ADDENDUM NO. 4 – FINAL

Williams Brice Stadium Plaza Site Upgrades – Construction

State Project No. H27-6104-MJ-B

SK-L1

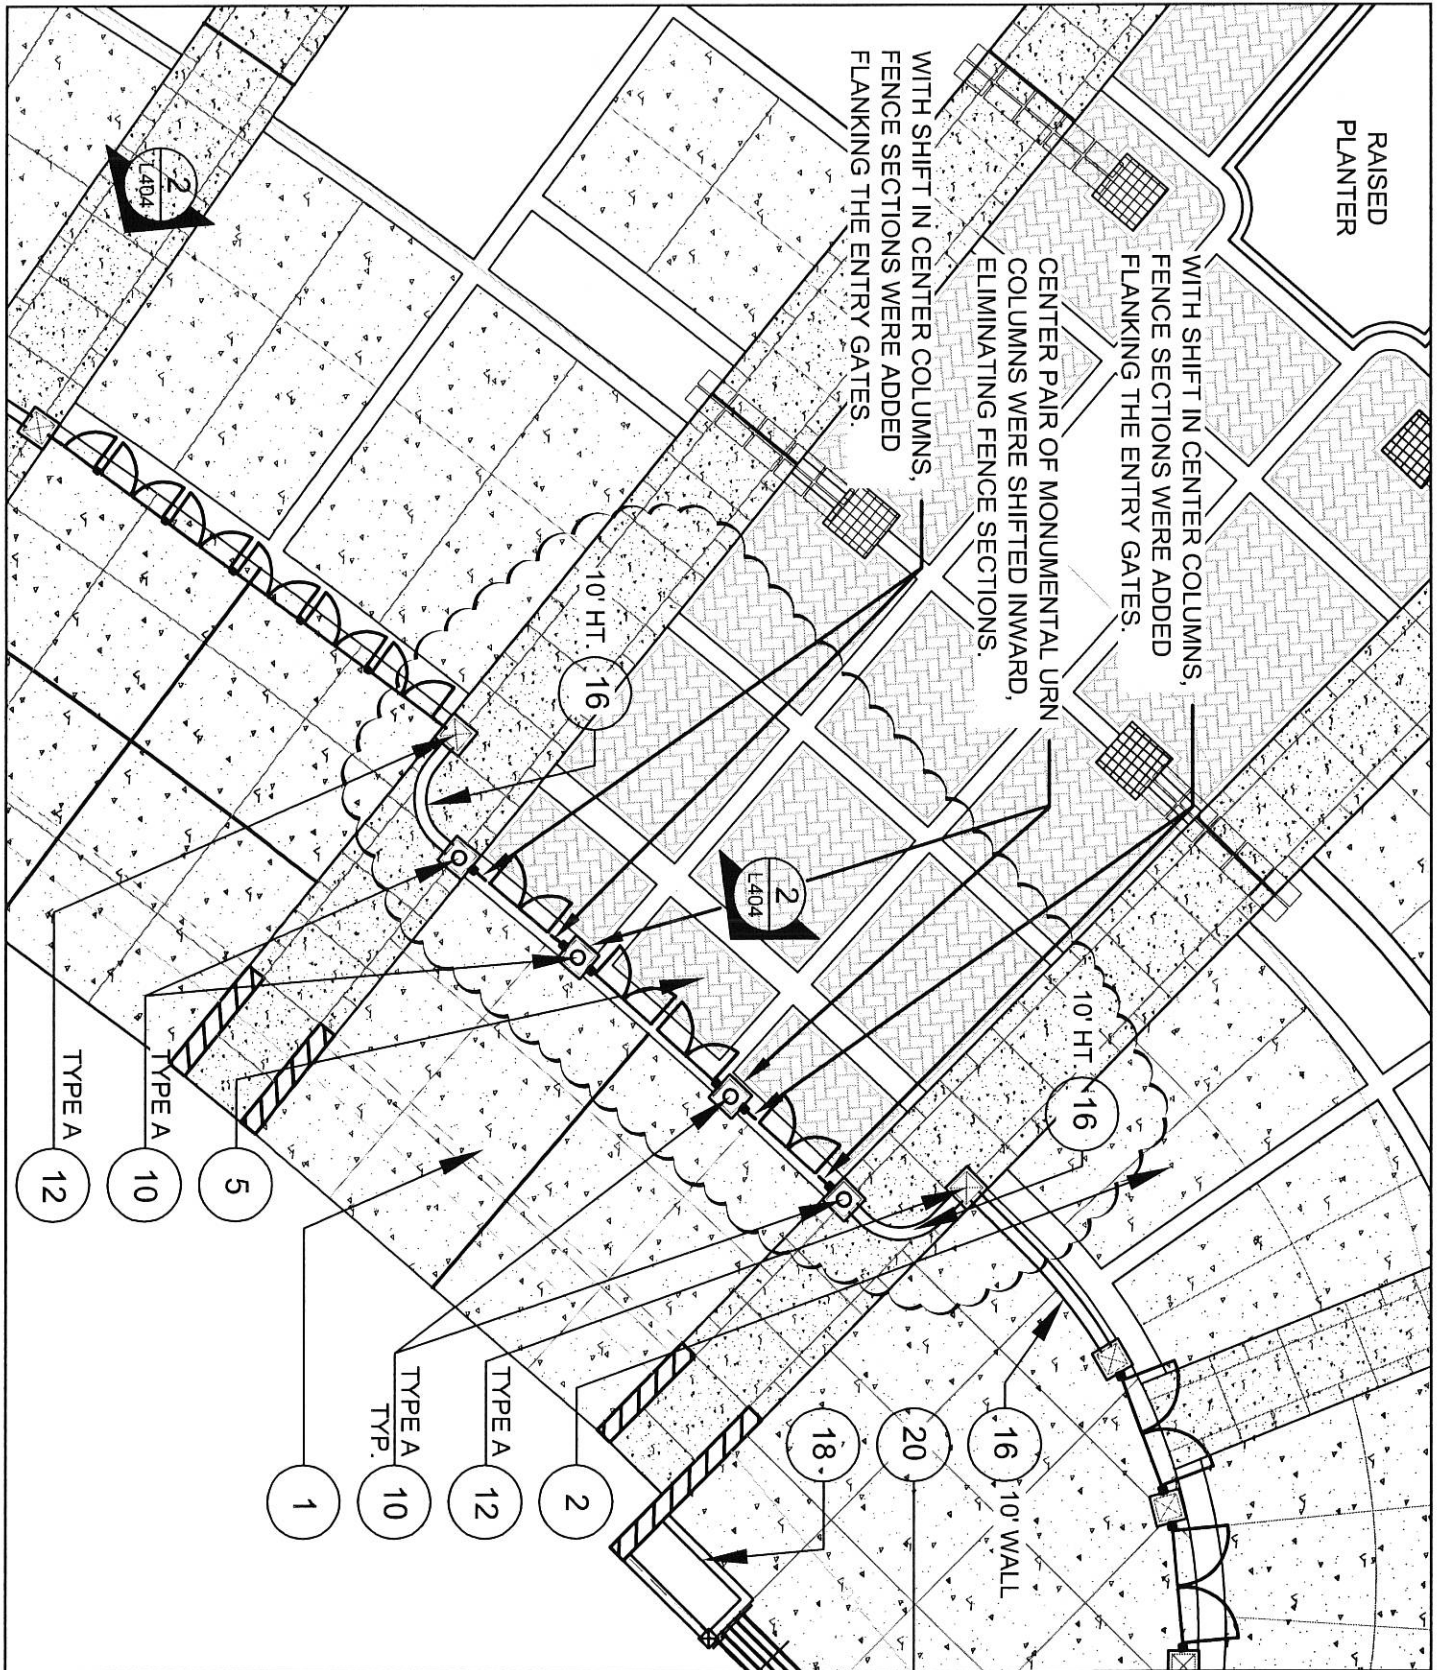
6. Drawing Sheet L101:
 - A. Sketch SK-L1 modifies the primary entry gates, fencing and transoms at the NW entrance.
 1. Center pair of monumental urn columns were shifted towards each other (inwardly) and fence sections eliminated from same location.
 2. With shift in center columns, gates flanking the center columns were shifted (so as to remain centered between columns) and fence sections were added. This condition was repeated on both sides of the primary entrance.

- c. Northwest Main entrance (L101) is 53' wide inside the two outside columns. The details referenced (2 L404) scales to 43'10". One pair of doors appear to be missing on the elevation. **Answer: See items 6 and 7 above.**

DRAWING NUMBER: **SK-L2**
REFERENCE DETAIL: **2/L404**

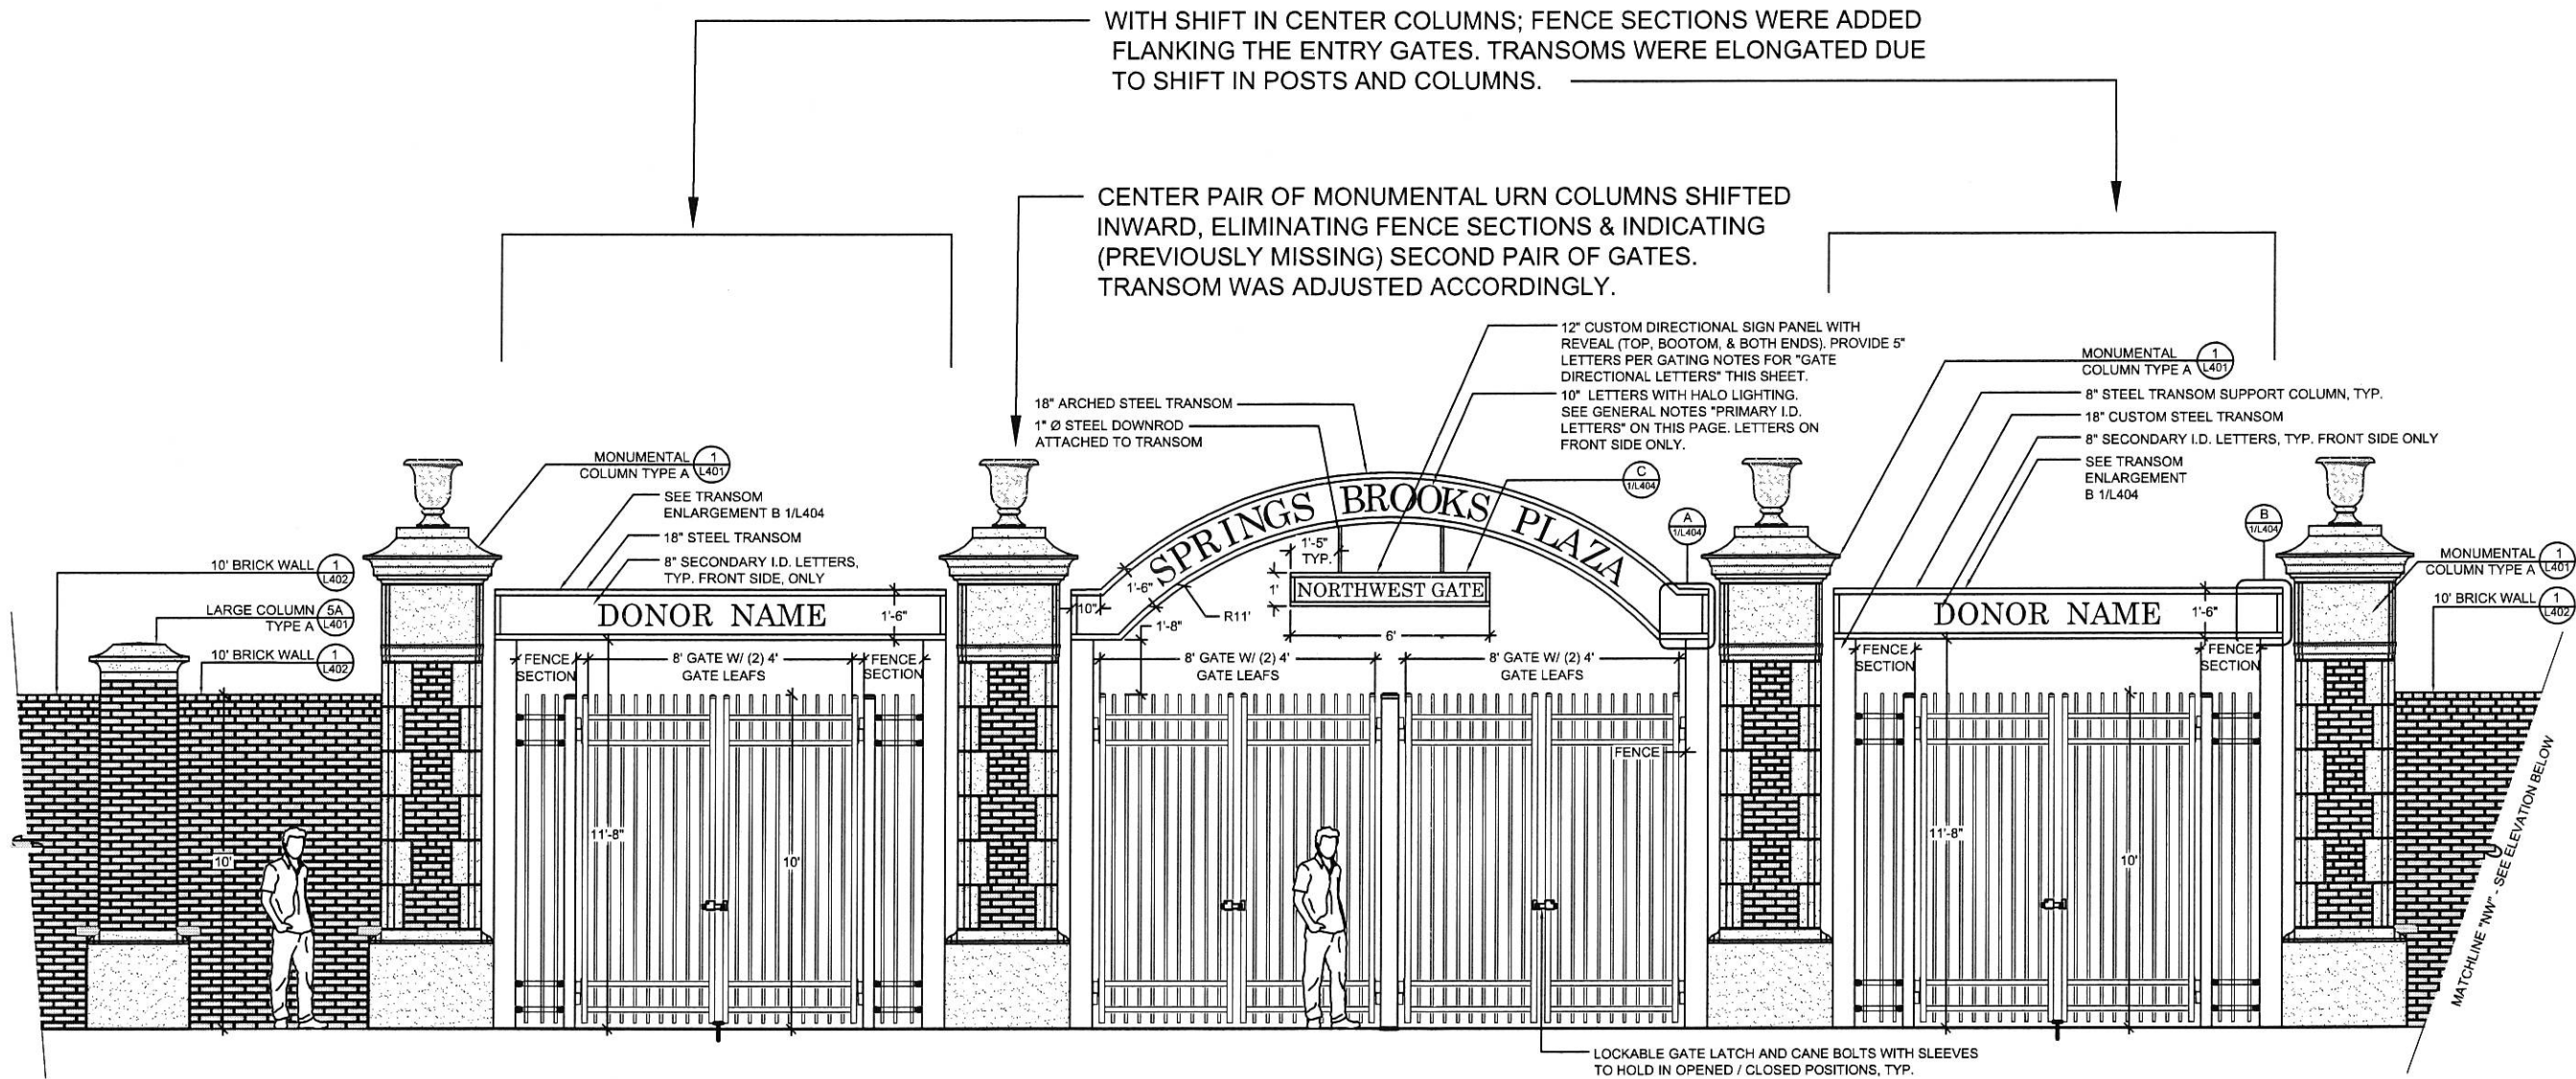
7. Drawing Sheet L404:
 - A. Sketch SK-L2 modifies detail 2/L404- Fence/Gate Elevation: Northwest Entrance
 1. Center pair of monumental urn columns shifted towards each other (inwardly) and fence sections were eliminated from same location. Elevation was modified to indicate two pairs of gates (one pair was previously missing) between center columns. Fence sections between center pair of columns were eliminated. Transom length was adjusted accordingly.
 2. With shift in center columns, gates flanking the center columns were shifted (so as to remain centered between the columns) and fence sections were added. This condition was repeated on both sides of the primary entrance. Transom lengths (both flanking sections) were adjusted to accommodate the shift in posts and columns.
